Addendum No. 5 **Issued: November 25, 2026**

Project Name:	Pottsgrove High School Facilities & Athletic Improvements ICS Project No. S25009
Project Owner:	Pottsgrove School District 1301 Kauffman Road Pottstown, PA 19464
Construction Manager:	ICS – Scott Kennedy 1400 N. Providence Road Building 2, Suite 4025 Media, PA 19063

MECHANICAL PLAN - VISITORS SIDE PAVILION

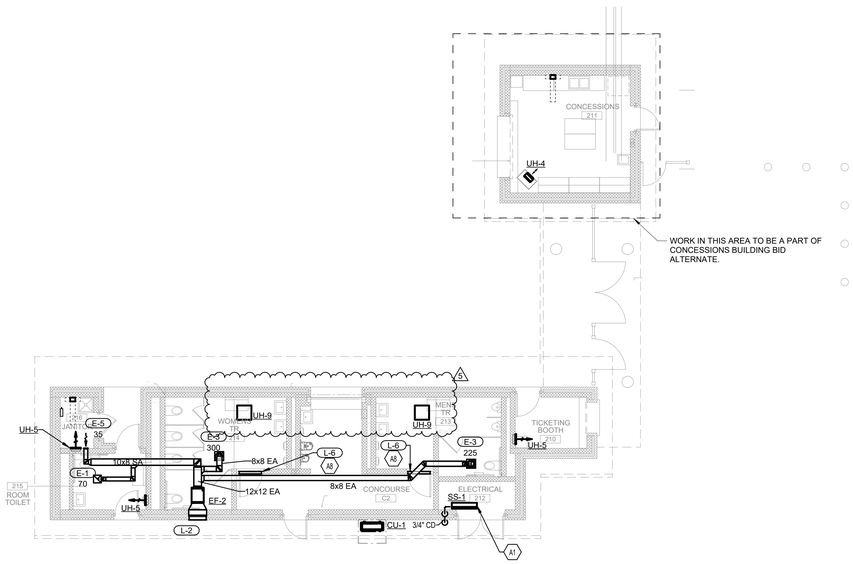
5.1 Drawing M-202 “Mechanical Plan – Visitors Side Pavilion”, **DELETE** in its entirety and **REPLACE** with the revised and reissued Drawing M-202 “Mechanical Plan – Visitors Side Pavilion”, included as an attachment to this Addendum. Updated unit heaters UH-2 in rooms 213 and 214 to be UH-9. Specifically changing these unit heaters from 480V/3 phase to 208V/3 phase.

ELECTRICAL SITE UTILITY PLAN - NORTH

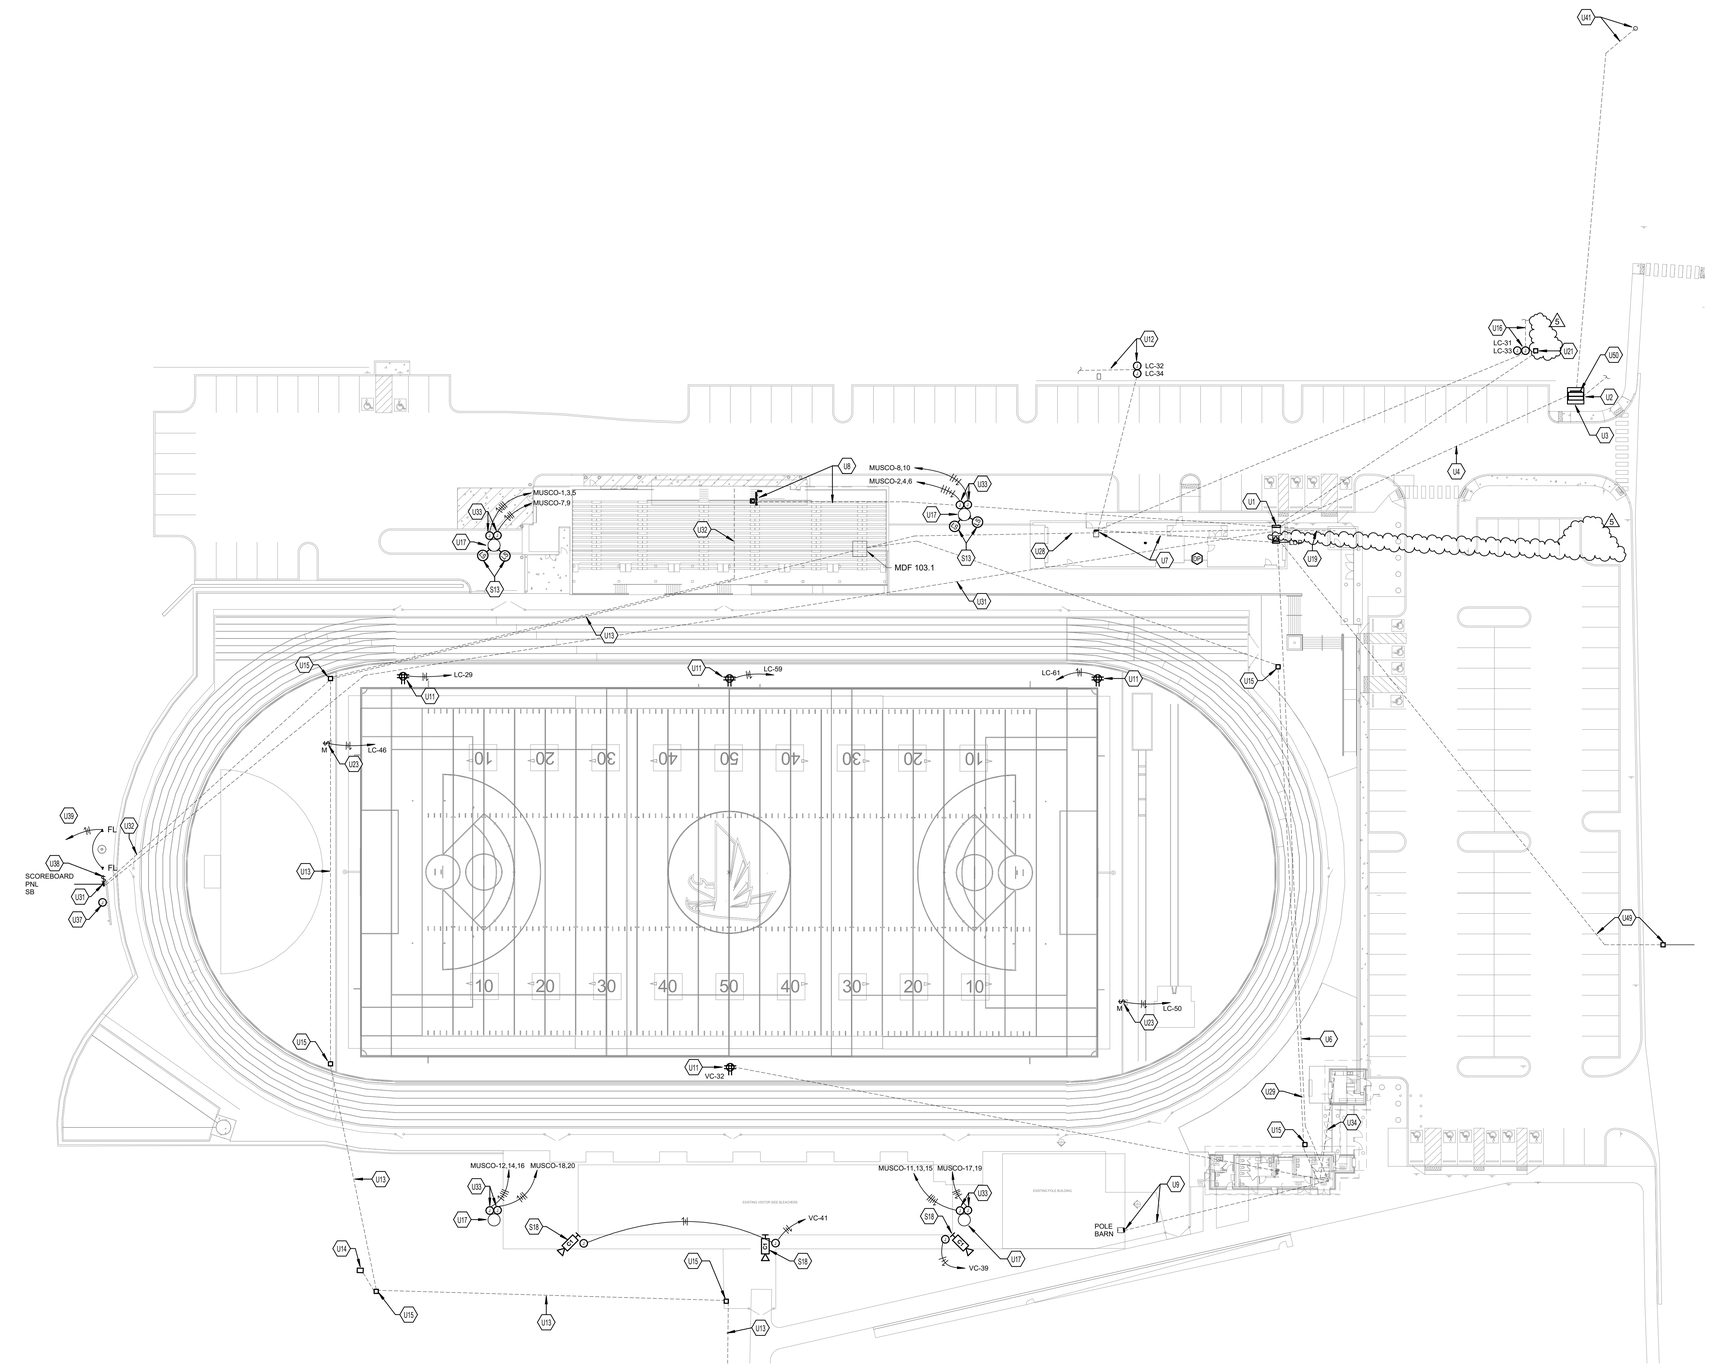
5.3 Drawing EU-101 “Electrical Site Utility Plan – North”, **DELETE** in its entirety and **REPLACE** with the revised and reissued Drawing EU-101 “Electrical Site Utility Plan – North”, included as an attachment to this Addendum. Removed Note U22 and scope related for the conduit and fiber run as shown on the site plan. Revised Note U21 to indicate that scope will only require a conduit to a handhole that is shown on plan. Scope from handhole to baseball backstop for conduit and fiber will be future work.

6.10 **Question:** Dwg EU-101 Note U16 has the EC intercepting and extending an existing conduit and feeder from the Baseball Backstop. However Note U21 calling for 4" conduit to existing Baseball Backstop does not specify whether the conduit between the new handhole and Baseball Backstop is existing or new. Please clarify whether the conduit from the handhole to the Baseball Backstop is existing or new. If the conduit from the handhole to the Baseball Backstop is not existing provide a drawing showing the location of the Baseball Backstop in relation to the handhole as it is not currently shown on the drawings.

6.11 **Question:** Addendum 4 Dwg E-800 now shows a 6-Strand fiber run from the Concessions IDF to the Baseball Backstop. Please verify whether this fiber is new and installed under this contract. If the fiber from the IDF to the Baseball Backstop is new provide a drawing showing the location of the Baseball Backstop in relation to the handhole as it is not currently shown on the drawings

6.12 **Question:** Dwg EU-101 there is a conduit run and handhole on the right side of the drawing with the U22 tag. Note U22 states "PROVIDE 4" CONDUIT WITH 12 STRAND SINGLE MODE FIBER OPTIC CABLE FROM RESTROOM BUILDING ELEC RM 212 TO CONCESSION 211 WALL RACK." This note is the same as note U34 and does not seem to apply to the conduit or handhole. Please advise.

Response: See revised drawing EU-101.

Response: Fiber to the baseball backstop is not part of this project. See revised drawing EU-101.

Response: See revised drawing EU-101.

POWER PLAN - HOME SIDE PAVILION

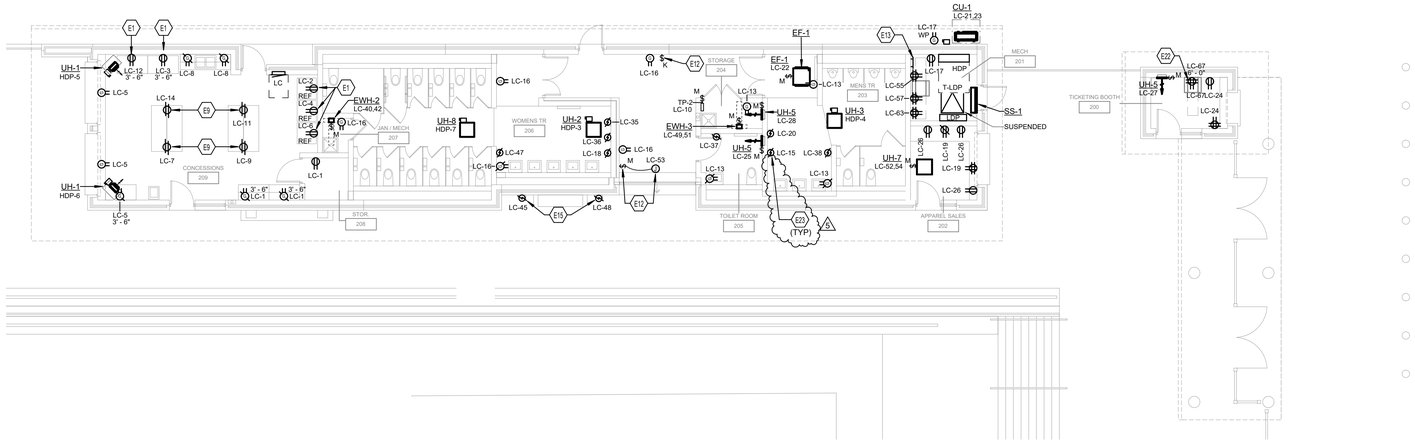
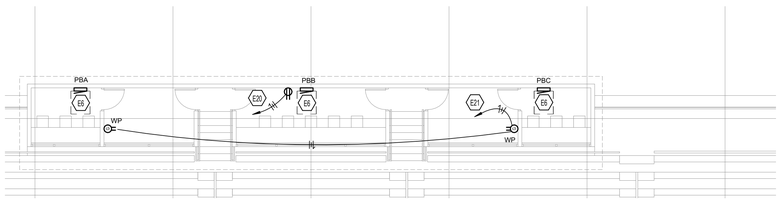
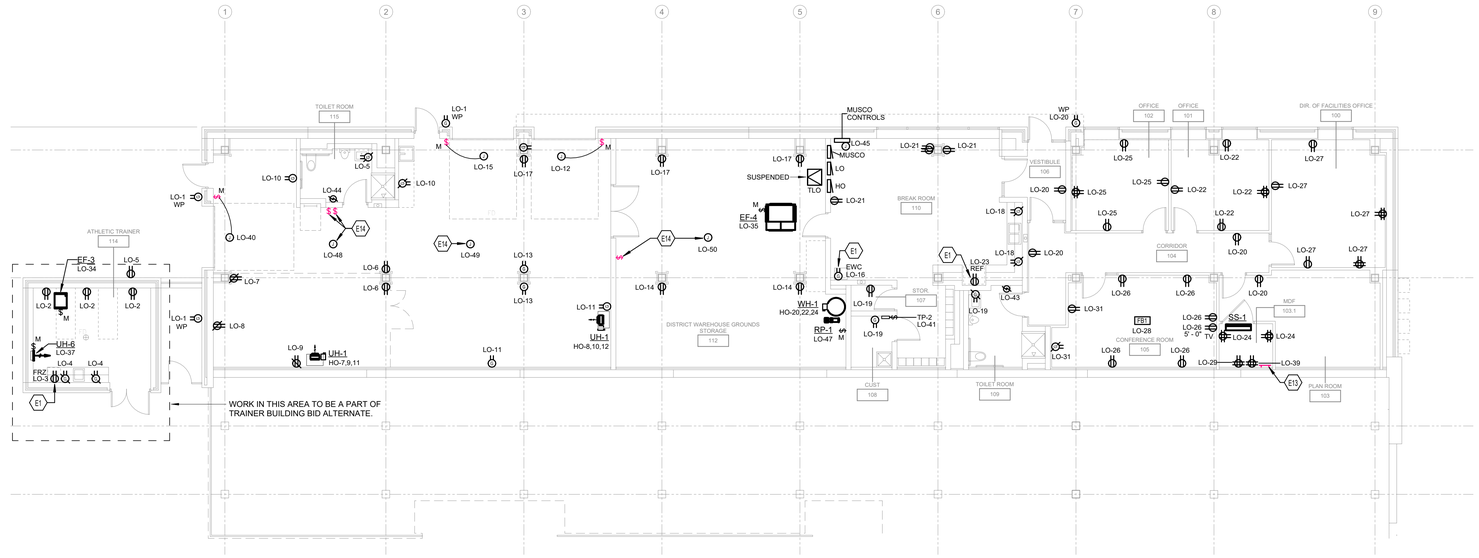
5.4 Drawing E-201 “Power Plan – Home Side Pavilion”, **DELETE** in its entirety and **REPLACE** with the revised and reissued Drawing E-201 “Power Plan – Home Side Pavilion”, included as an attachment to this Addendum. Added Note #23 to indicate the basis of design for the Hand Dryers to meet ADA requirement.

6.9 **Question:** I noticed in the spec for hand dryers that it only mentioned Basis of Design Product: "By EC". I am "assuming" that means electrical contractor. Can you please tell me what hand dryers you are looking for in this project?

Response: See Note #23 on revised drawing E-201 and E-202.

POWER PLAN - VISITORS SIDE PAVILION

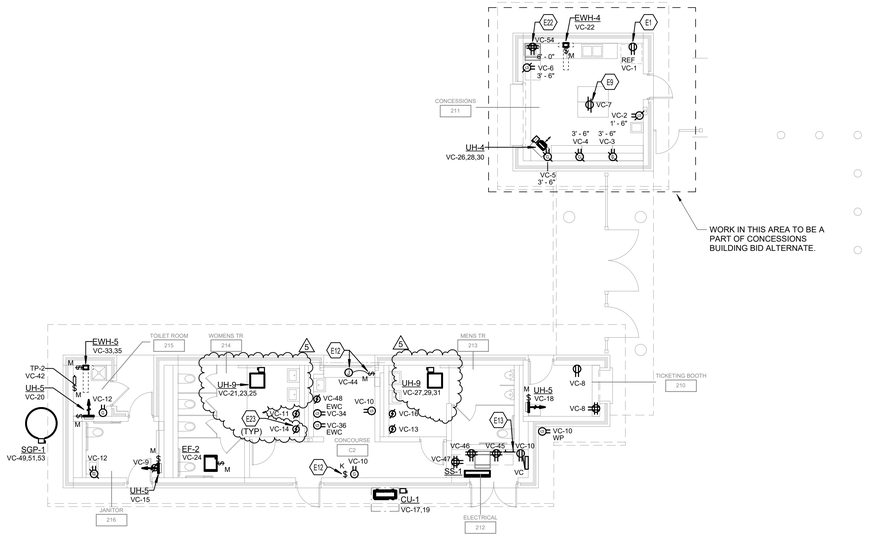
5.5 Drawing E-202 “Power Plan – Visitors Side Pavilion”, **DELETE** in its entirety and **REPLACE** with the revised and reissued Drawing E-202 “Power Plan – Visitors Side Pavilion”, included as an attachment to this Addendum. Added Note #23 to indicate the basis of design for the Hand Dryers to meet ADA requirement. Updated two UH-2 heaters to UH-9 heaters
